Access Compliance Report

Public Rights-of-Way

(Curb Ramps)

Intersection ID: 49137	Main Street: LESTER_HILL_CT	Cross Street: POPE_FARM_RD	Location: SW
ADA ID: 62F3DEA424B8	Ramp Type: PerpDiag	Initial Pass/Fail: Fail	Overall Compliance: No
Severity Score: 13.75			
Codes/Mitigation Info/Possible Solution		Field Measurements/Component Compliance

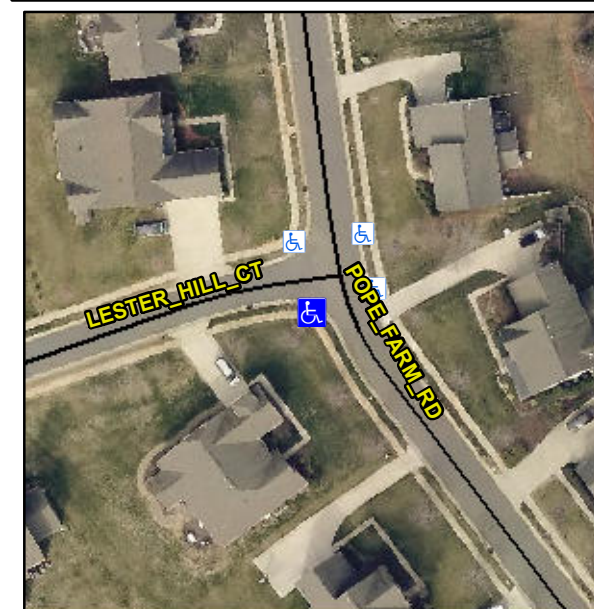
Not Found, R304.2.2, R304.5.3

Compliance	Description	Data	Compliance	Description	Data
N/A	Ramp Length (in)	48.0	No	Ramp Slope (%)	9.4
Yes	Ramp Width (in)	48.0	No	Ramp XSlope (%)	3.3
N/A	Flare Type LT	N/A	N/A	Flare Type RT	N/A
N/A	Flare Slope LT (%)	N/A	N/A	Flare Slope RT (%)	N/A
N/A	Flare Traversable LT?	N/A	N/A	Flare Traversable RT?	N/A
N/A	Landing Length (in)	N/A	N/A	DWS Provided?	N/A
N/A	Landing Width (in)	N/A	N/A	DWS Contrast?	N/A
N/A	Landing Slope (%)	N/A	N/A	DWS Length (in)	N/A
N/A	Landing X Slope (%)	N/A	N/A	DWS Full Width?	N/A
N/A	Landing Curb? (Y/N)	N/A	N/A	DWS Offset (in)	N/A
N/A	Shared Landing?	N/A			
N/A	Gutter Ponding?	N/A	N/A	Gutter Slope (%)	N/A
N/A	Gutter Lip Ht (in)	N/A	N/A	Gutter X Slope (%)	N/A
N/A	Painted X Walk1?	No	N/A	Painted X Walk2?	No
	X Walk 1 Direction	To E		X Walk 2 Direction	To N
N/A	X Walk 1 Width (in)	N/A	N/A	X Walk 2 Width (in)	N/A
	X Walk 1 Slope (%)	0.5		X Walk 2 Slope (%)	3.3
	X Walk 1 X Slope (%)	2.5		X Walk 2 X Slope (%)	2.2

Remove & Replace Curb Ramp With Two New Directional Ramps or Equivalent.
